Appendix A – Approximate Section Sketches showing proximity of proposed basements to Lyndhurst Hall

Re: OPINION OF BASEMENT IMPACT ASSESSMENT FOR 11 ROSSLYN HILL, LONDON NW3 5UL

Geotechnical and Environmental Associates Limited (GEA) has been instructed by Air Studios (Lyndhurst) Limited to undertake an initial review of the geotechnical and groundwater aspects of a BIA for proposed basement at a neighbouring site, namely No 11 Rosslyn Hill. Concerns have been raised in respect of the potential impact of the proposed basement on the Grade II* listed Lyndhurst Hall which is in use as an orchestral recording studio. This report provides an initial review of the BIA and raises items of concern where the submission does not appear to satisfy the requirements of Camden Planning Guidance CPG4¹.

Figure 3: Sketch showing proximity of new underground cinema in relation to the foundations of Lyndhurst Hall (including various measurements taken from BIA)

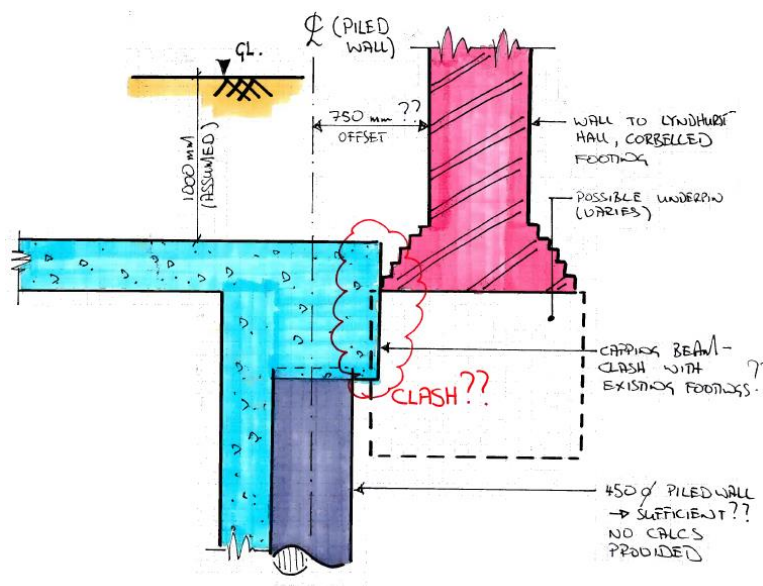
A single trial pit has been dug to expose the foundations of Lyndhurst Hall, the results of which have been extrapolated across the entire building by the engineers compiling the BIA, based on the assumption that it represents the footings to the entire building. The trial pit however is unlikely to be typical. Neither is it clear from the BIA as to where the trial pit was made, as the sketches and drawings provided are contradictory. It is understood from our client that Lyndhurst Hall was partially underpinned during its conversion in the early 1990s and in some areas beneath the building there are basements, resulting in the foundations being of variable depth.

The foundation construction of Lyndhurst Hall will strongly influence the proposed adjacent basement design and construction and requires more extensive consideration in the BIA. Where the foundations are shallower they may not prevent perched groundwater flows through the made ground layer over the London Clay beneath our Client's building, as assumed in the BIA, and where there are underground features this needs to be considered properly in the design, construction and location of the new basement. See figure 3 below for a detailed section showing the existing foundations and the proposed basement, deduced from the information provided, which suggests that the basement is too close to Lyndhurst Hall.

Figure 4: Potential undermining of foundations to Lyndhurst Hall during construction of adjacent basements (depending upon extents of existing concrete footings)

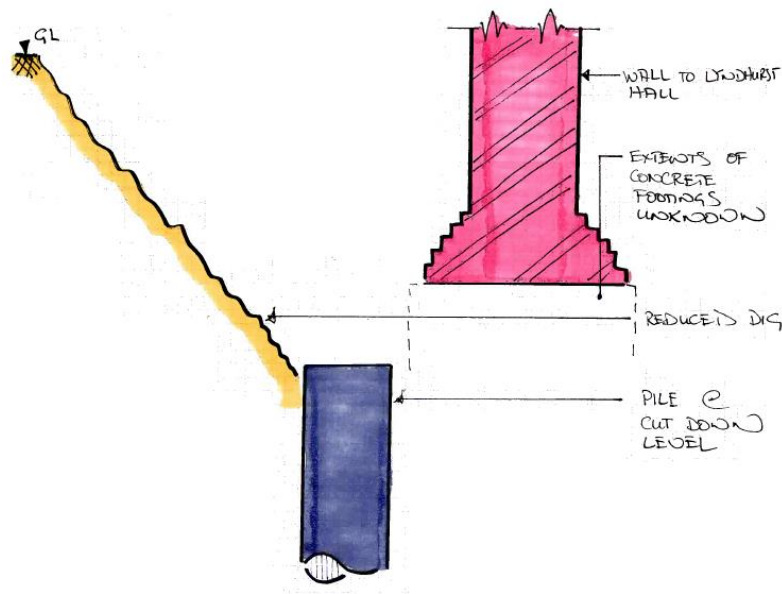
The proposed basement drawings describing the cinema show this to be located extremely close to our Clients' building; further study may show

this to be too close – the proximity will make it practically very difficult to construct as can be seen from the sketch in figure 4 below, as the extents of the concrete underpinning to Lyndhurst Hall has not been investigated in the BIA.

SK. B SKETCH SECTION SHOWING PROPOSED UNDERGROUND SWIMMING SHOWN ADJACENT TO AIR STUDIOS MAIN HALL
~1:100 @ A3

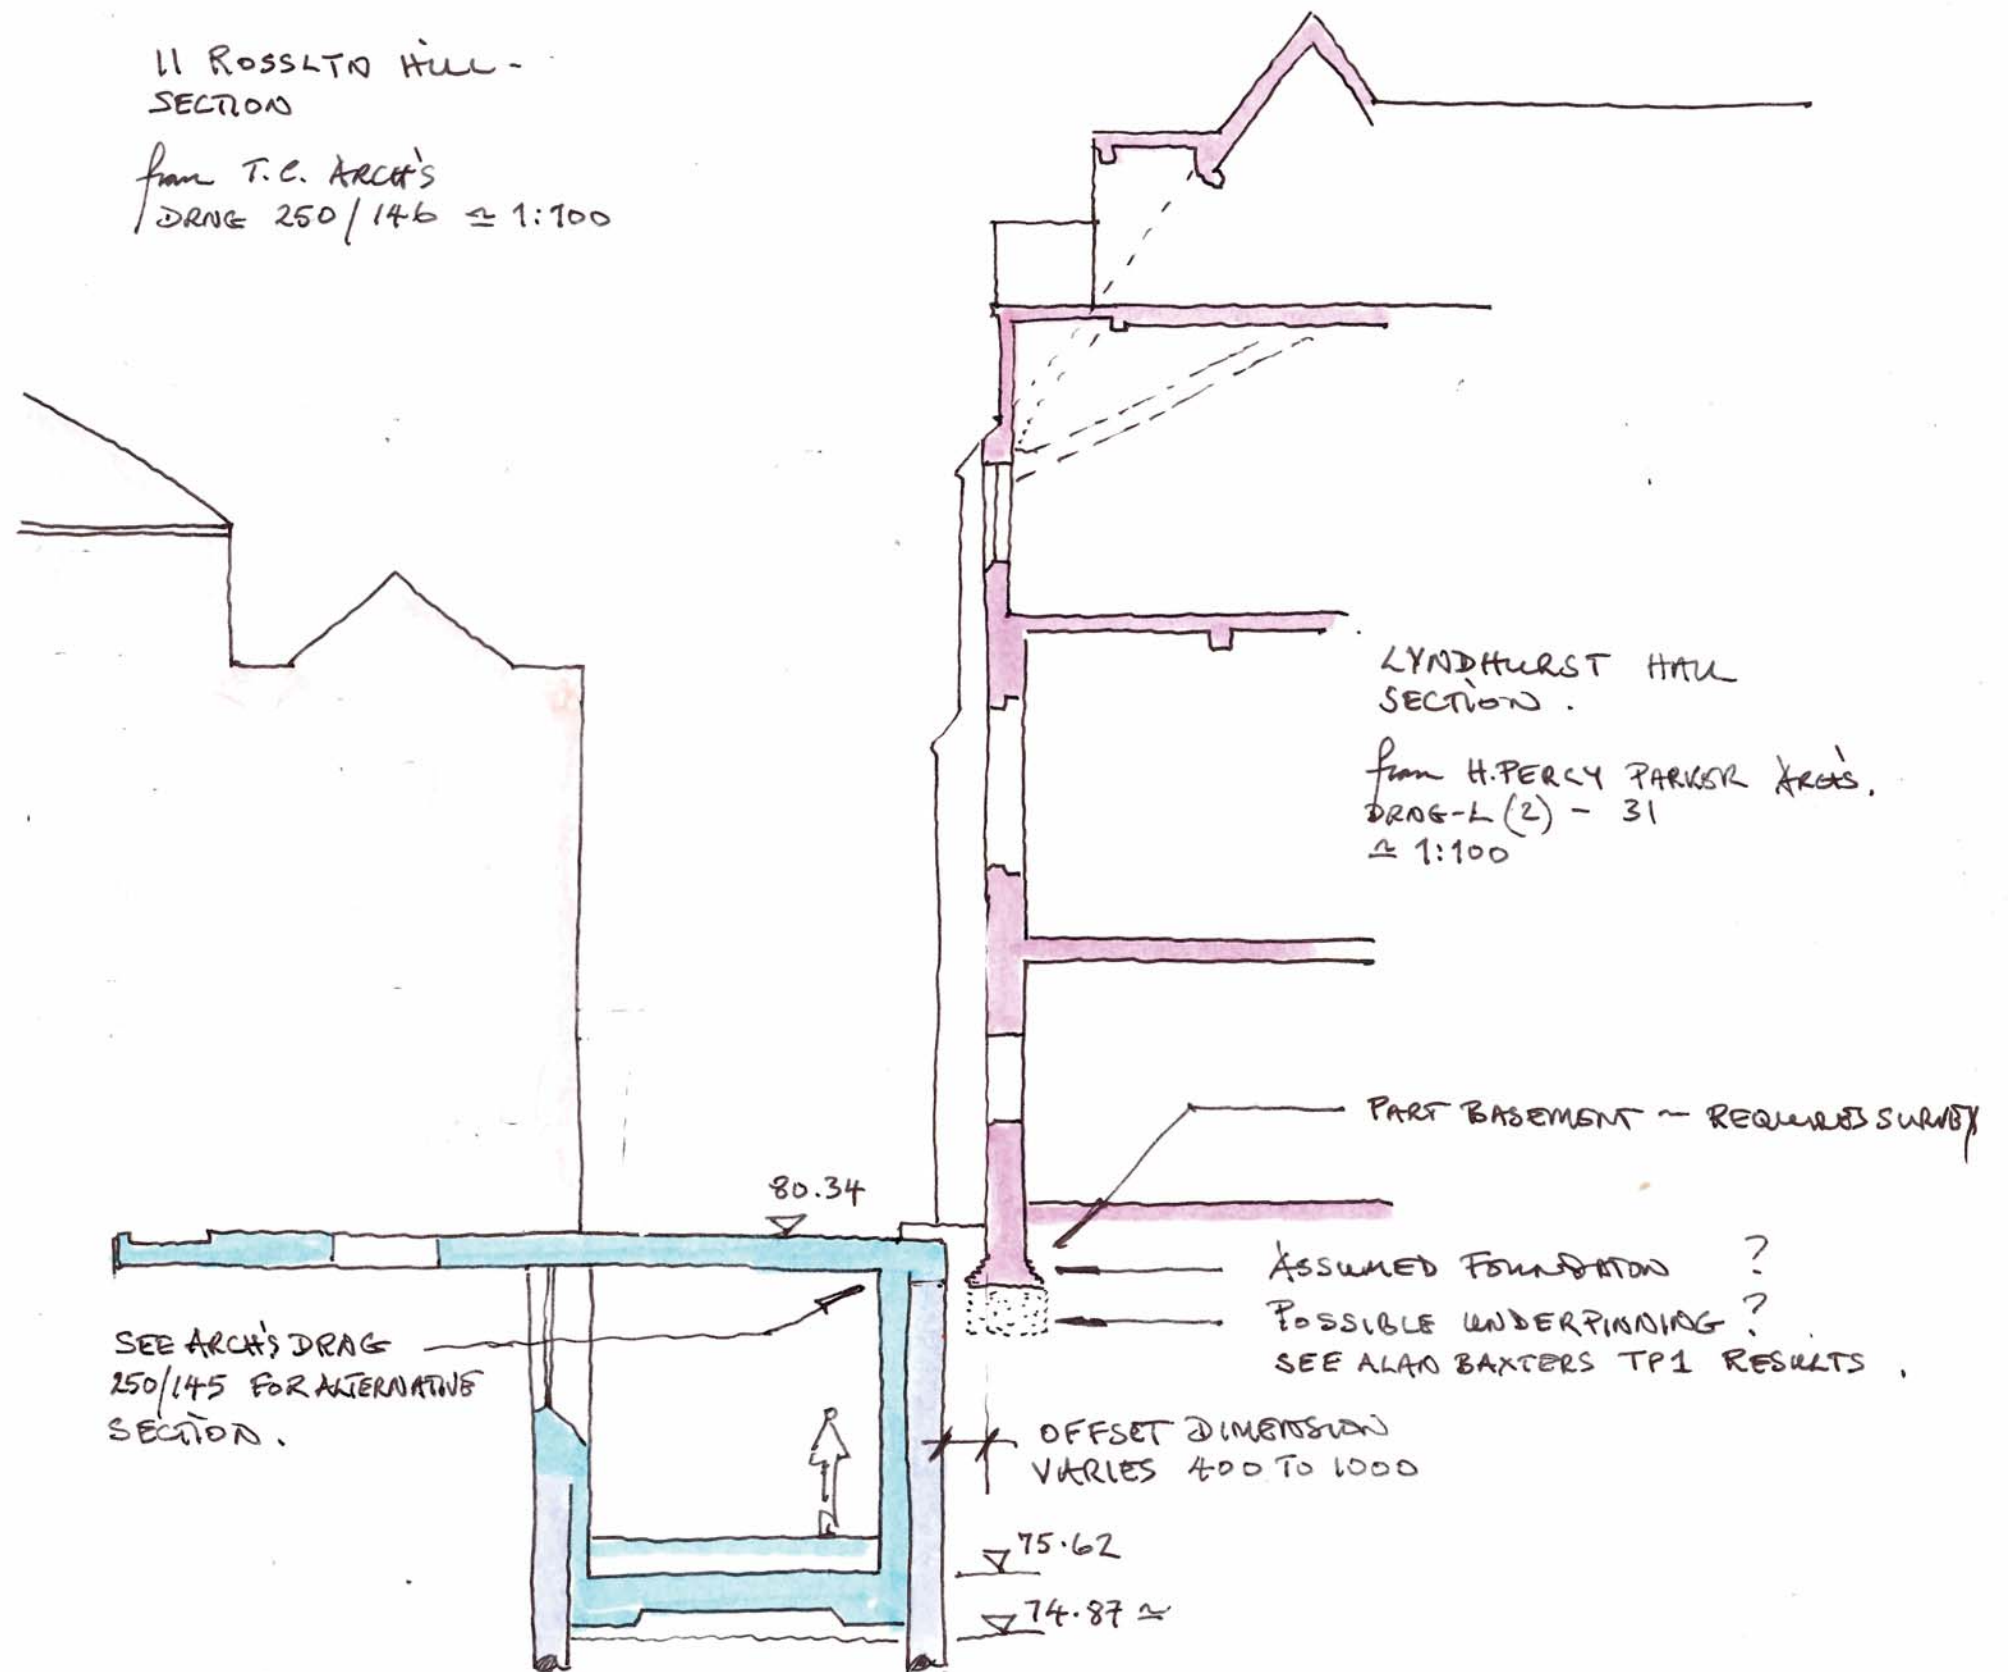
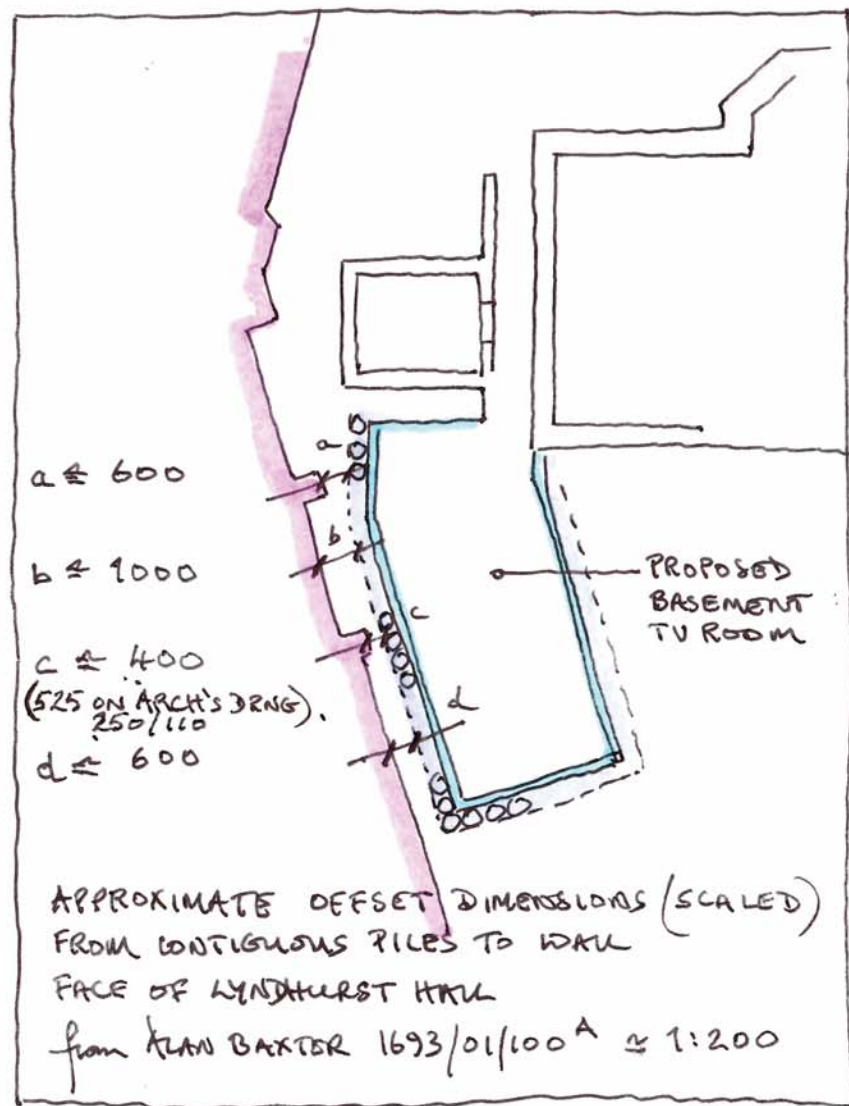
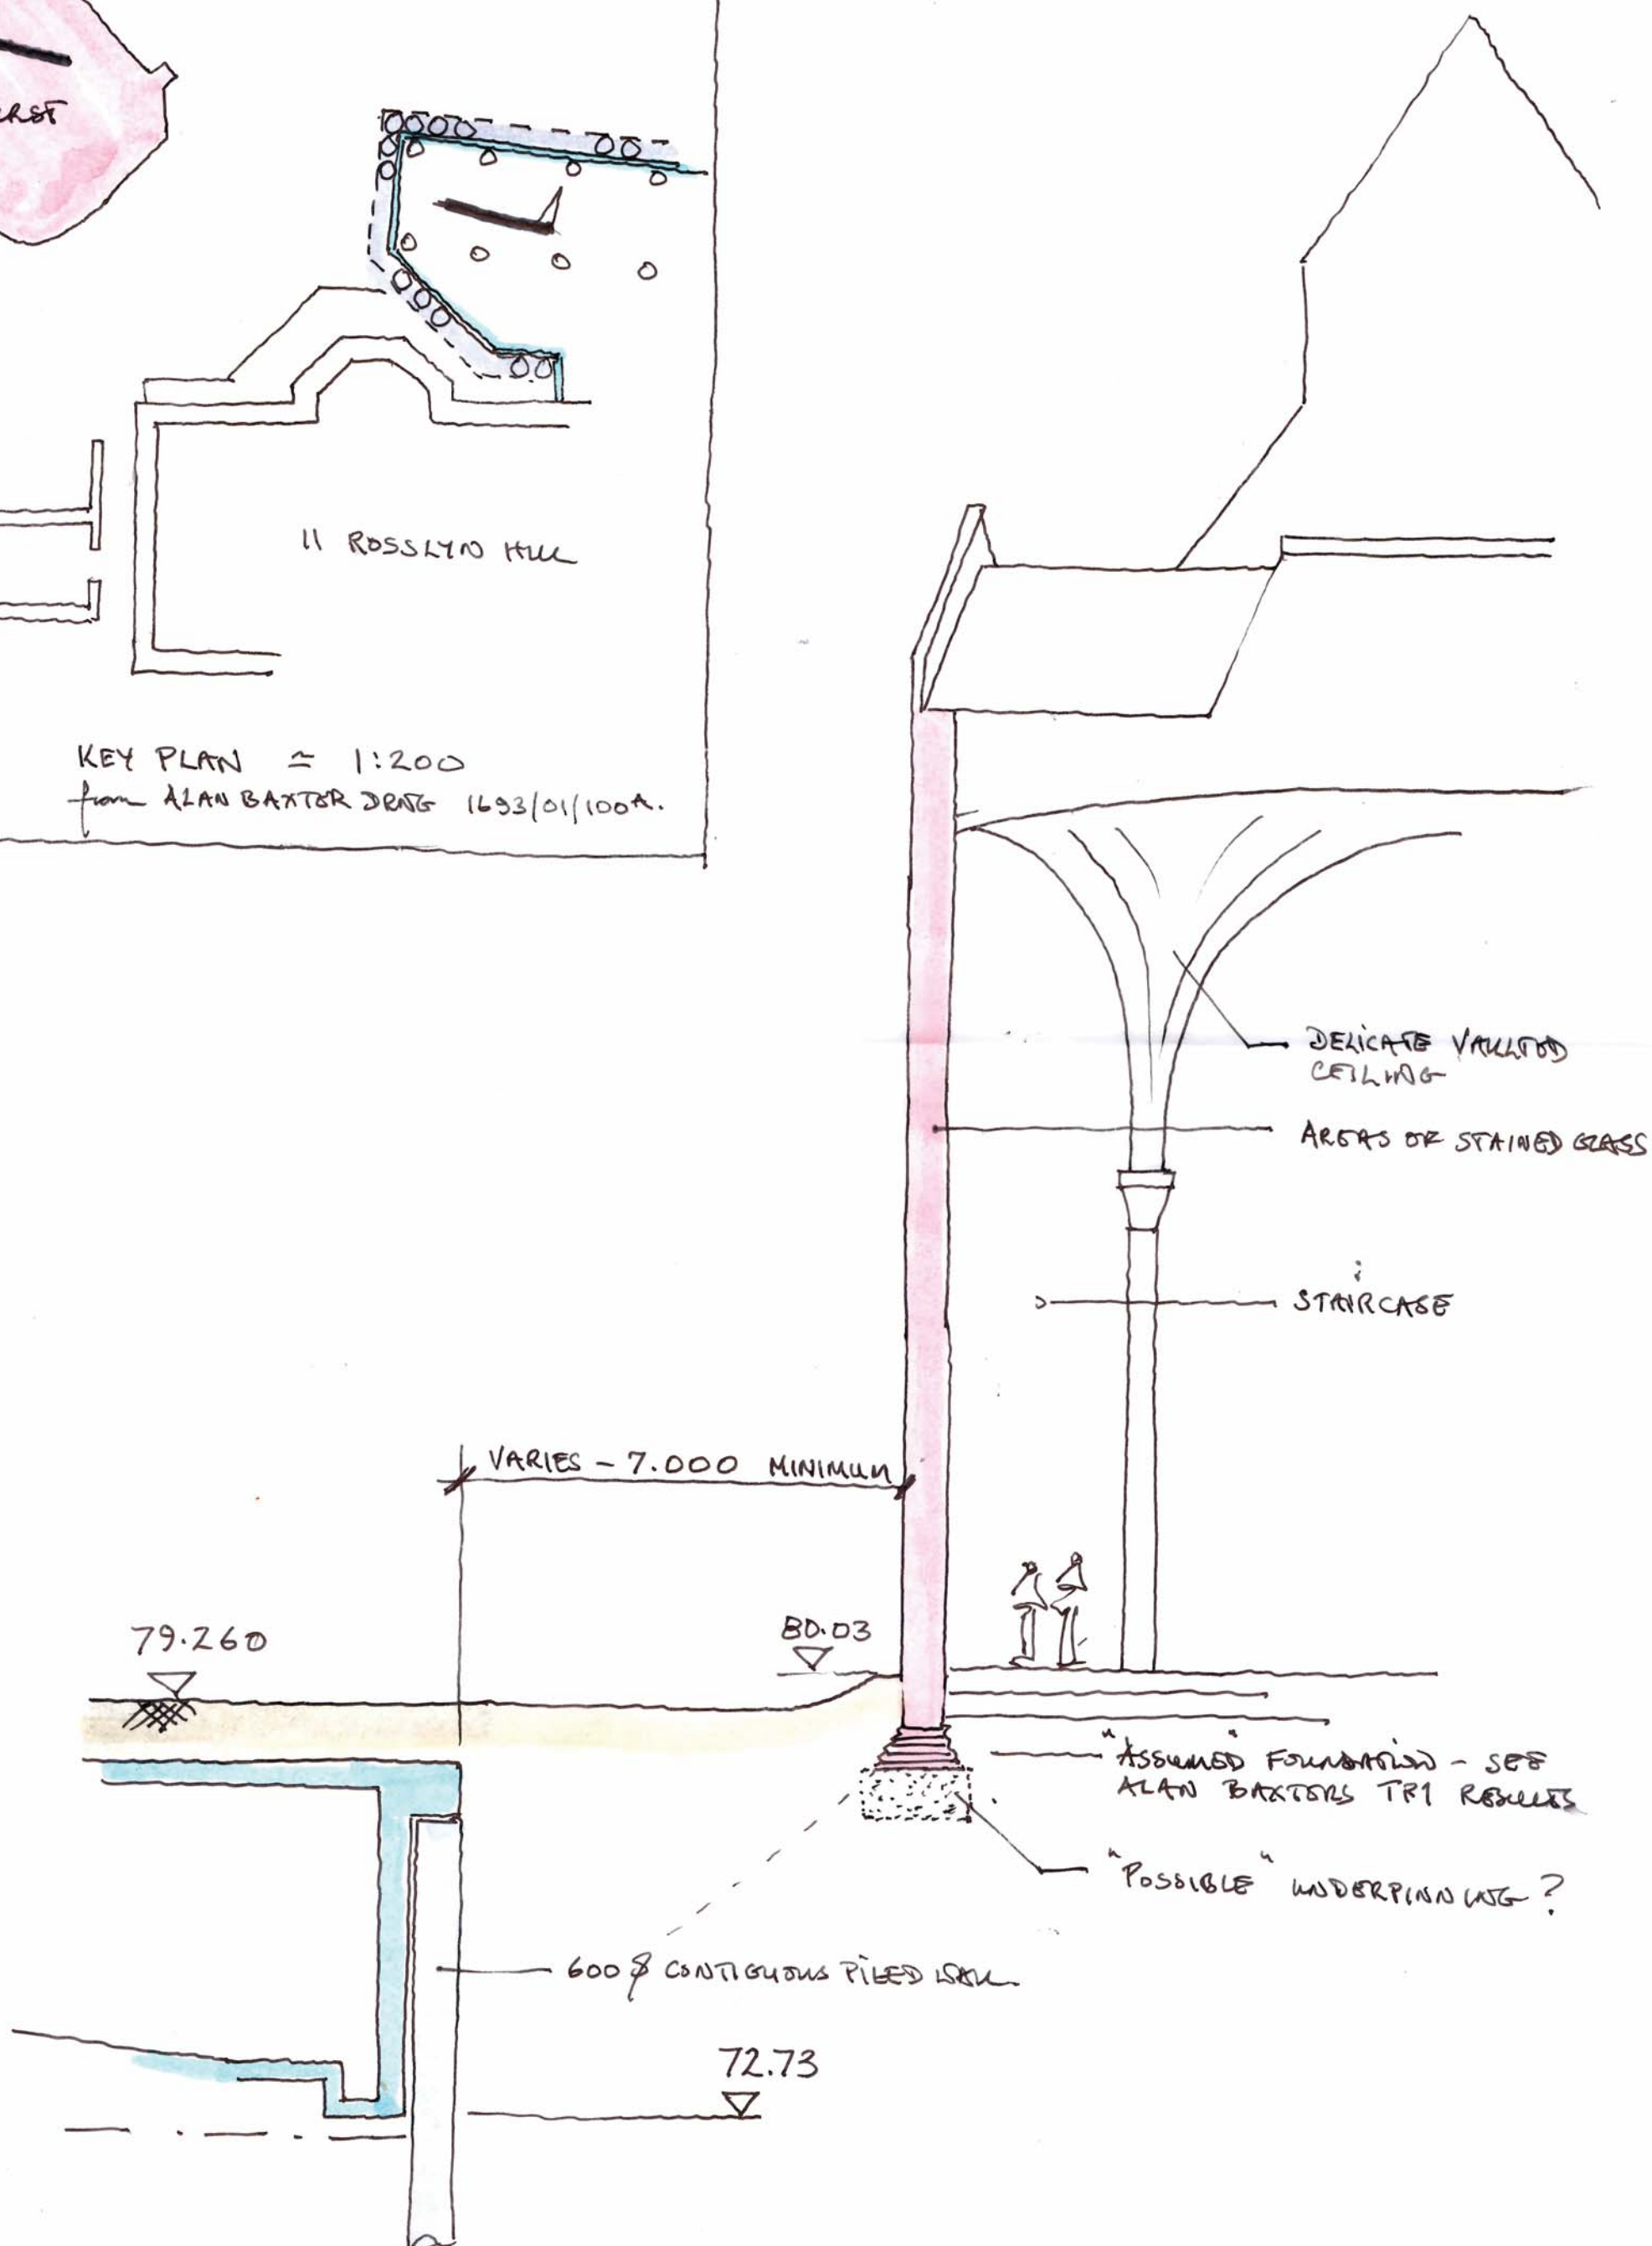
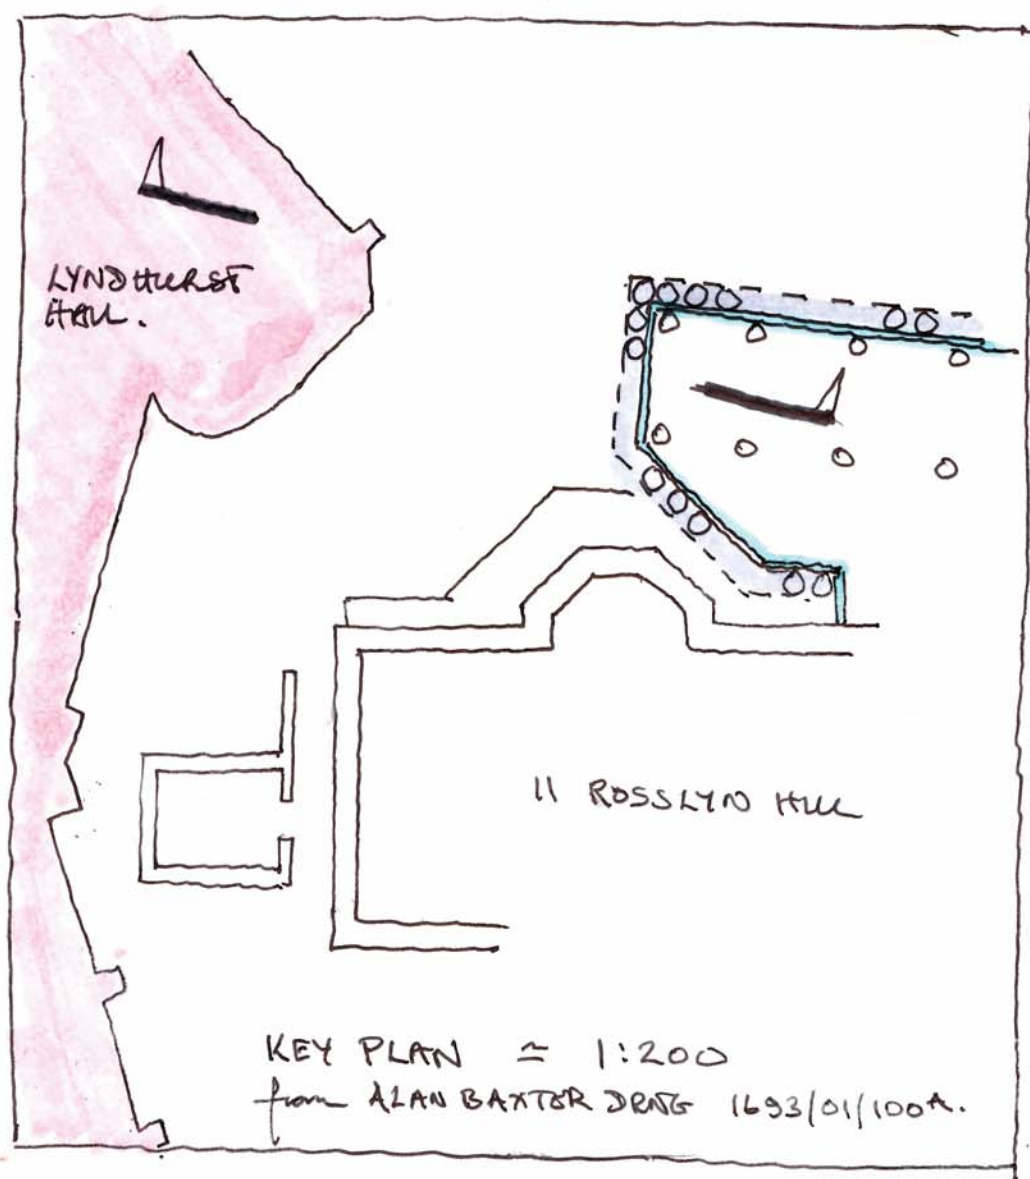
7. More section drawings are required, showing the interface between new basement and existing structures, to fully understand the structural interaction

8. New piles are proposed extremely close to Lyndhurst Hall's corbelled brick foundations; a more detailed study may well reveal the close proximity is impractical
